Natural Resources Division

Project Review Summary

Prepared for the Environmental Advisory Board

PMCP-24-00000041- 75 PARK PLACE

PID 0786011001

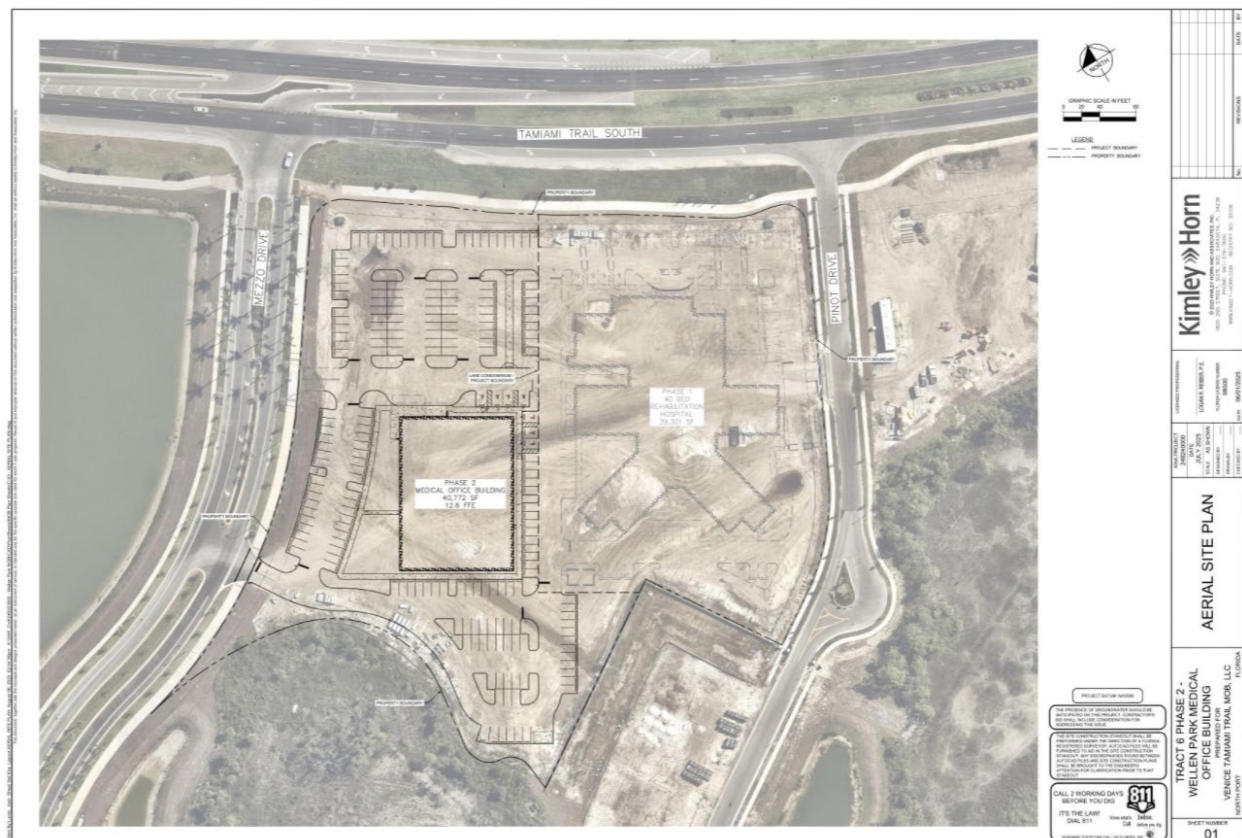
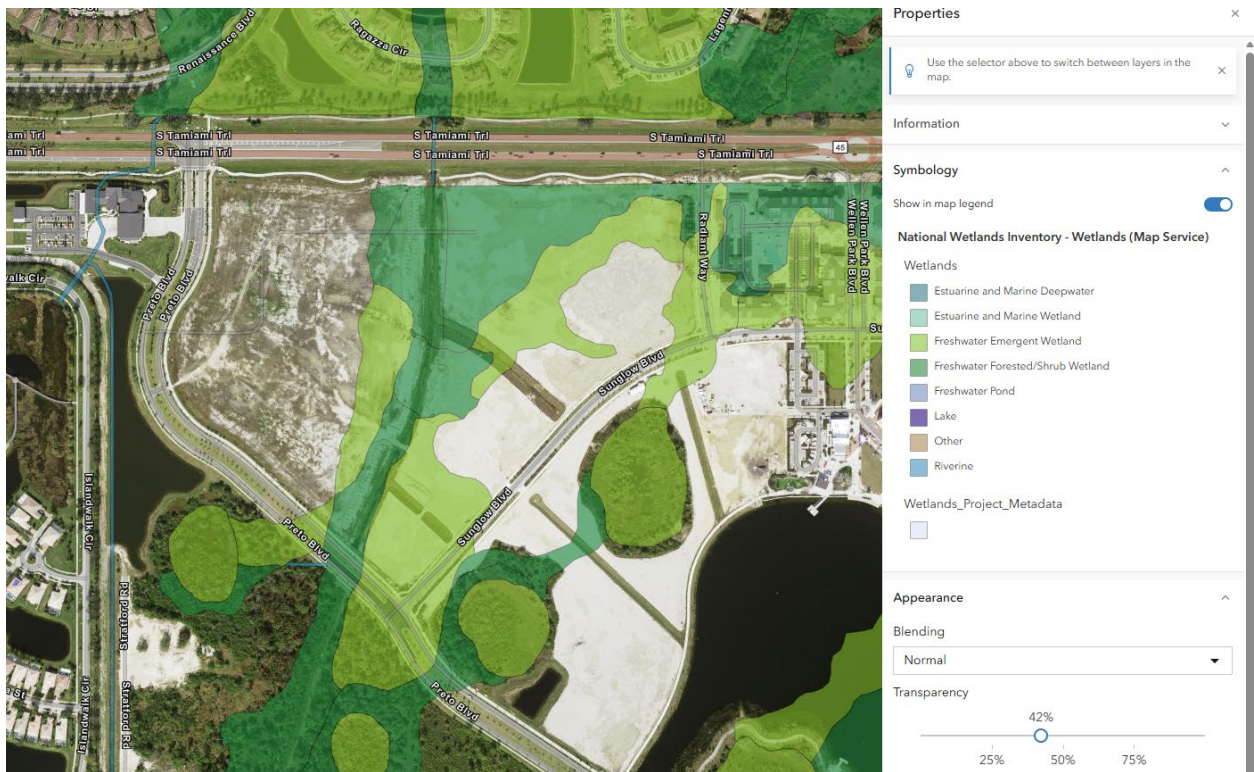
1. The applicant must plant all trees and landscaping in accordance with code regulations. They should follow the “right tree, right place” policy. No medium or large canopy trees should be planted within 20 feet of overhead utilities. Trees classified as small may be planted adjacent to power lines, with a recommended six-foot setback. Palms that can grow taller than 10 feet must be placed with a setback equal to their maximum frond length plus 3 feet.
2. A root barrier must be installed when a tree is within 10 feet of any street, sidewalk, driveway, underground utilities, or structure (see Section 4.3.2).
3. The property owner or their successor is responsible for maintaining all landscaping materials in a healthy condition, as approved, indefinitely. They must also replace any landscaping materials that are damaged, diseased, dead, or considered hazardous (see Section 4.3.1).

PSDP-25-03691 - Sarasota Memorial Hospital North Port - Phase 2

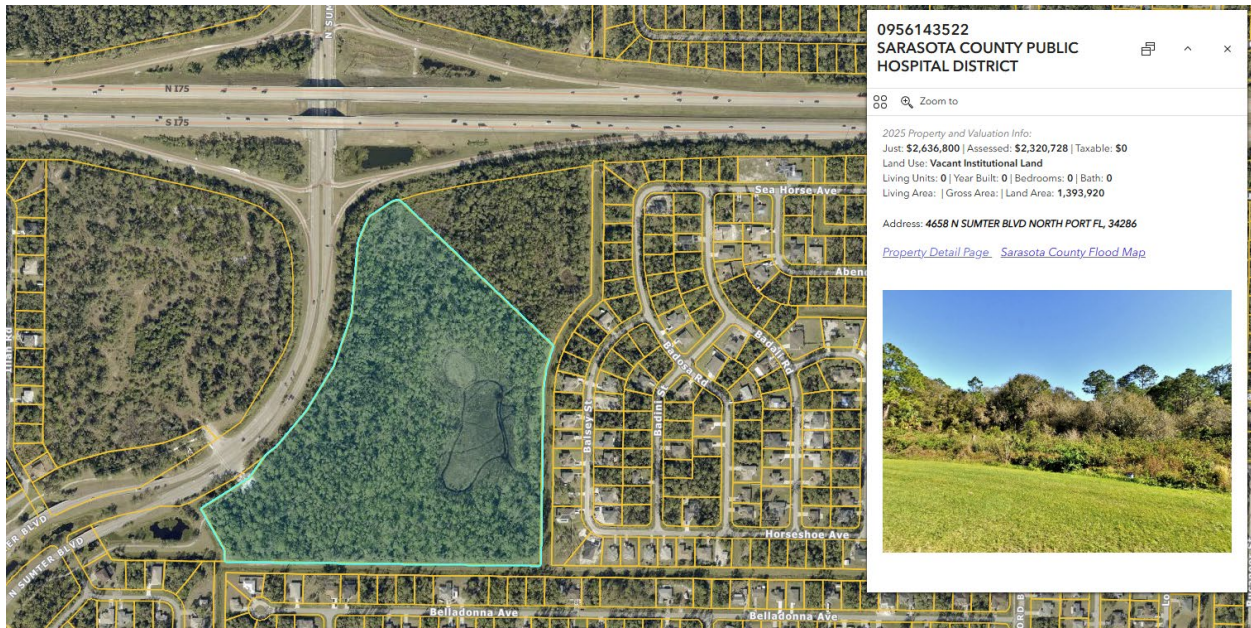
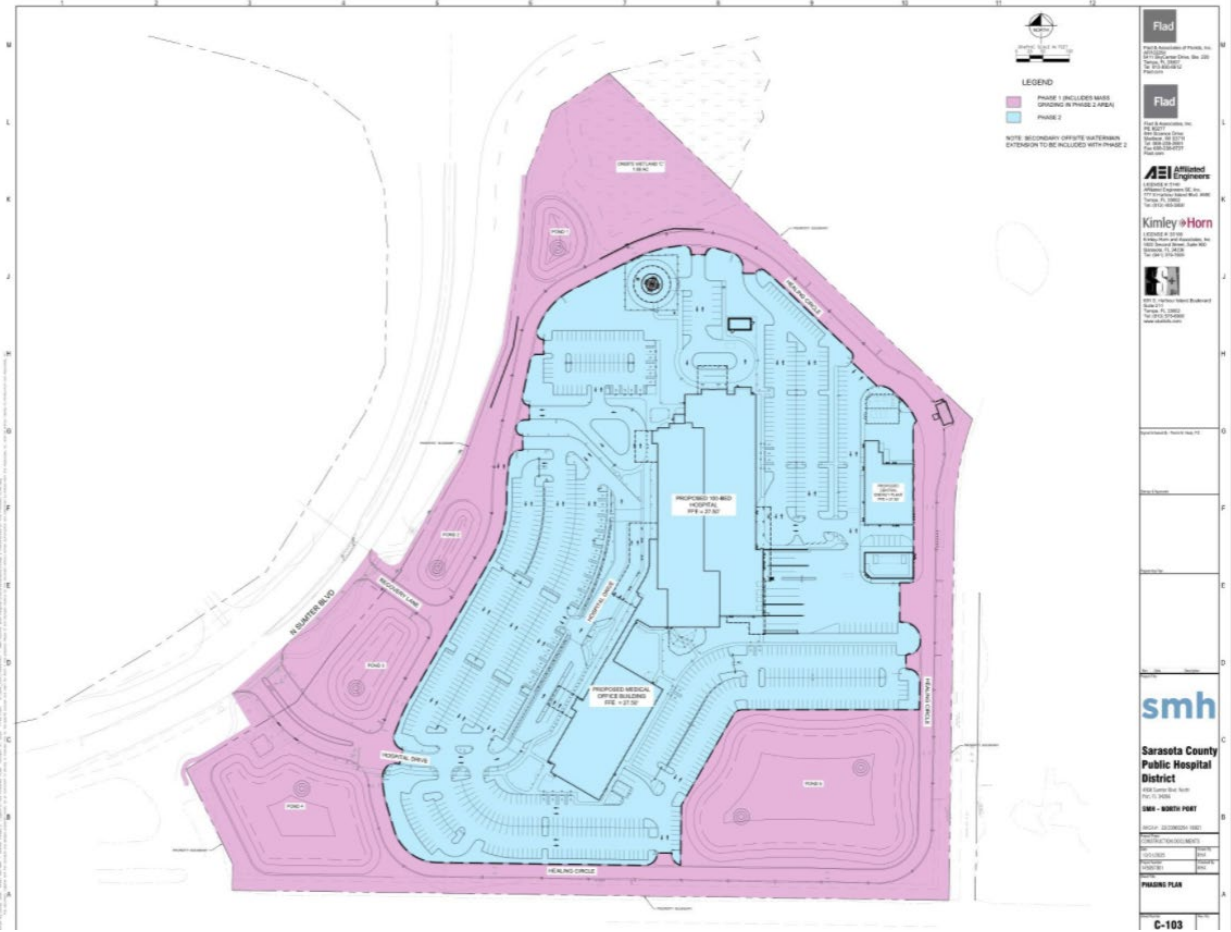
1. The applicant must plant all trees and landscaping in accordance with code regulations. They should follow the “right tree, right place” policy. No medium or large canopy trees should be planted within 20 feet of overhead utilities. Trees classified as small may be planted adjacent to power lines, with a recommended six-foot setback. Palms that can grow taller than 10 feet must be placed with a setback equal to their maximum frond length plus 3 feet.

2. A root barrier must be installed when a tree is within 10 feet of any street, sidewalk, driveway, underground utilities, or structure (see Section 4.3.2).

3. The property owner or their successor is responsible for maintaining all landscaping materials in a healthy condition, as approved, indefinitely. They must also replace any landscaping materials that are damaged, diseased, dead, or considered hazardous (see Section 4.3.1).

4. The wetland mitigation for the proposed project exceeds the amount approved in the SWFWMD permit. Copies of all required permits shall be provided prior to construction commencement (see Section 2.1.4. g)
